# Central Parc at North Port Pattern Plan Amendment

Petition No. PMCPA-24-00000114

Presented by: The Planning & Zoning Division

Request: Amend the Central Parc at North Port Pattern Plan to revise the buffer planting plan to remove plantings along the back of lakes adjacent to neighboring properties

CURRENT BUFFER PLAN

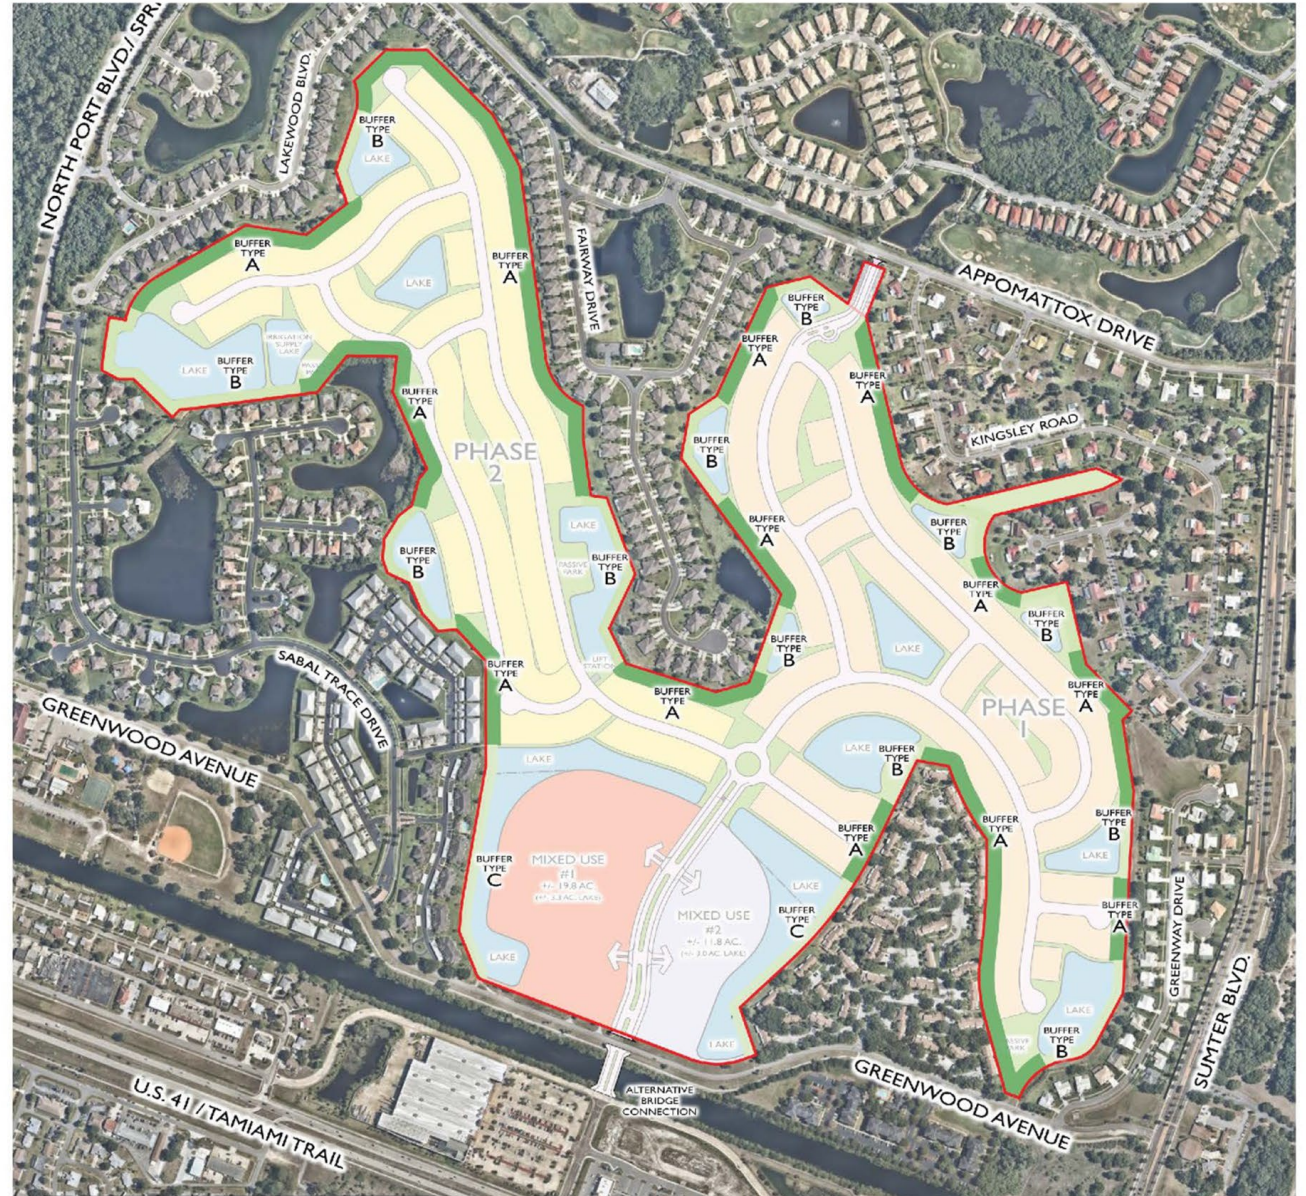
The request to eliminate plantings adjacent to Lake 5 is not supported. The 2010 ULDC requires a 10' Type B buffer where single-family/two-family residential is adjacent to multifamily uses. The approved Pattern Plan includes an enhanced buffer for added protection between different densities and heights. Retaining the enhanced buffer is essential for compatibility between current and future uses of the two districts.

The request to eliminate planting adjacent to Lake 9 is not supported. The 2010 ULDC requires a 10' Type B buffer in this location where single-family/two-family residential is proposed adjacent to existing multifamily uses. It is important to recognize that the adopted Pattern Plan has an enhanced buffer approved in this location providing additional protection between uses of varying density and heights. To ensure compatibility between current and future uses of the two districts, the enhanced buffer should be retained.

Staff does not support this waiver request. The buffer in this location provides screening between the entrance right-of-way from Appomattox Drive to the development, and the front and rear of existing single-family residential lots. Removing screening commitments in this location would create noise, light nuisance for the adjacent residences. Staff recommends retaining an enhanced buffer in this location.

**Option 1:** Approve the amended buffer plan as presented by the Applicant, without the grant of Waivers 1 and 2, and the change proposed to the buffer adjacent to Lake 13. Buffers adjacent to Lakes 5, 9, and 13 shall meet the planting/screening specifications of a Type 2 buffer.

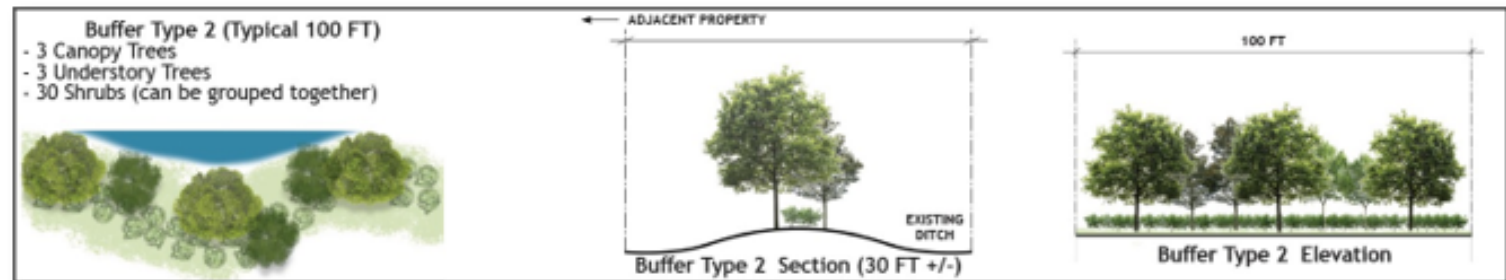
Staff also believes that the intent to provide views of the lake can be met by simply updating the Type B buffers to exclude the required berm and shrubs. Three (3) canopy trees and three (3) understory trees every 100 linear feet will not create visual barriers, and in fact, may create more scenic views of the lake, provided that the planting style is staggered and randomized to provide a less curated appearance.
